## Andrus Property, Preliminary Plan No. 120180130

Staff Report Date: 6/17/19

Request to subdivide seven (7) existing lots, into a total of fifteen (15) lots, for a total of eight (8) new single-family detached lots/houses.

### **Preliminary Plan No. 120180130**

Figure 5- Andrus Road

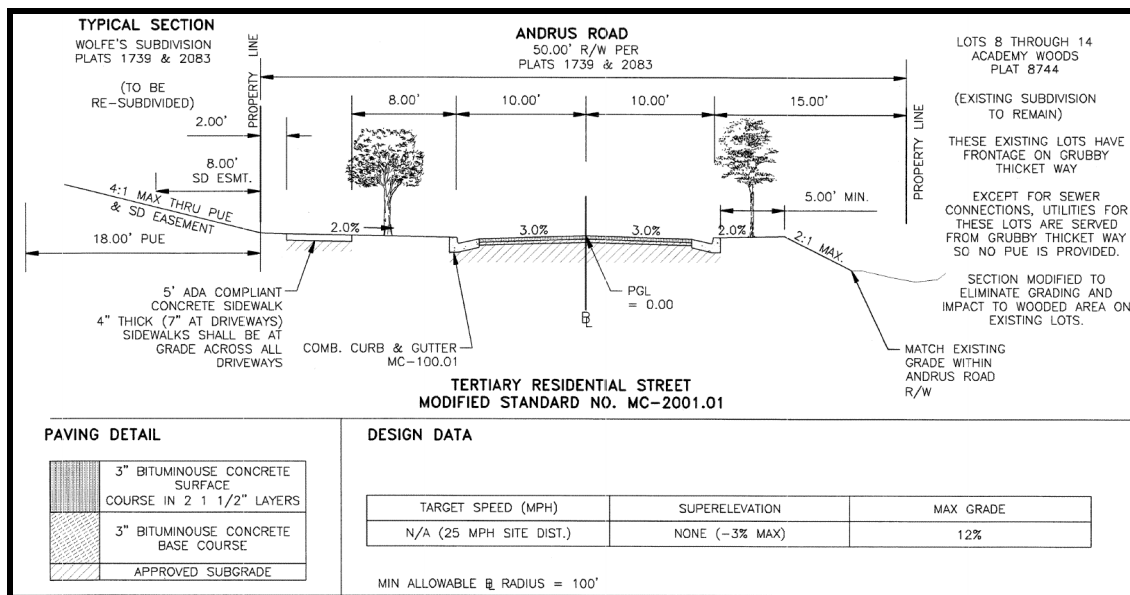
Proposed Andrus Road exists as a 50-foot-wide dedicated but unimproved secondary residential street. In order to reduce pavement width and tree impacts to existing mature trees within the right-of-way, Andrus Road will be constructed in accordance with Tertiary Residential standards (MC 2001.01), as shown in Figure 5, terminating in a modified cul-de-sac with a 110-foot diameter (Figure 6).

Figure 7- Greentree sidewalk

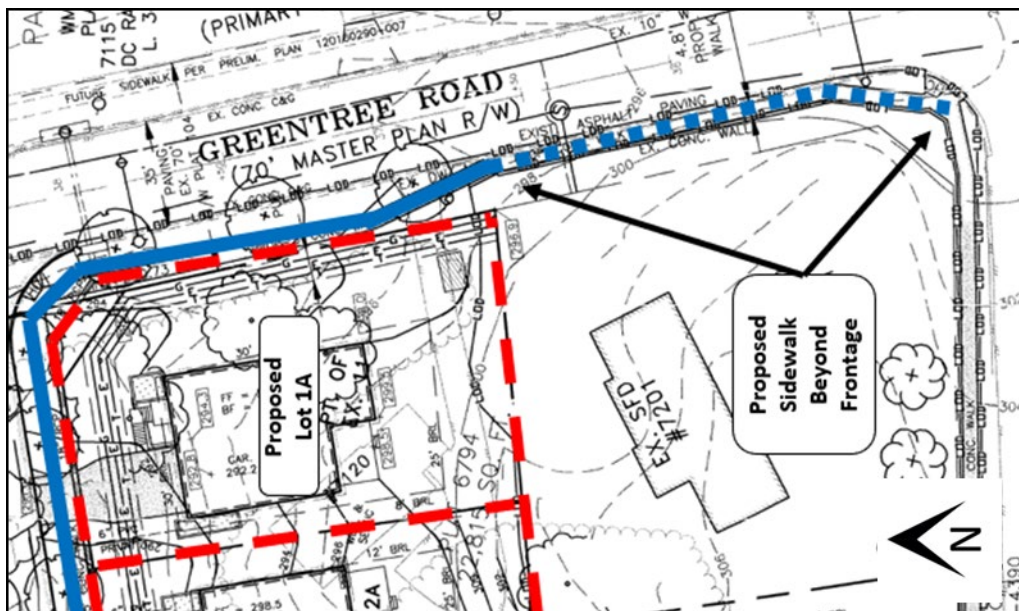
Andrus Road is not a master-planned road, however, it connects to Greentree Road, which has been constructed to its master-planned width of 70 feet. Greentree Road is classified as a primary residential street. The Applicant is required to provide sidewalks along the entire Property frontage, which includes Andrus Road, the west side of Greentree Road and the north side of Barnett Place. There is one property not included in this application at the corner of Greentree Road and Barnett Place, but the Applicant is required to provide a five (5) foot sidewalk along this stretch in order to provide one continuous facility, as shown in Figure 7 below. Along this property, the sidewalk will narrow below the standard to accommodate retaining walls located on private property, which fall outside the scope of the project.
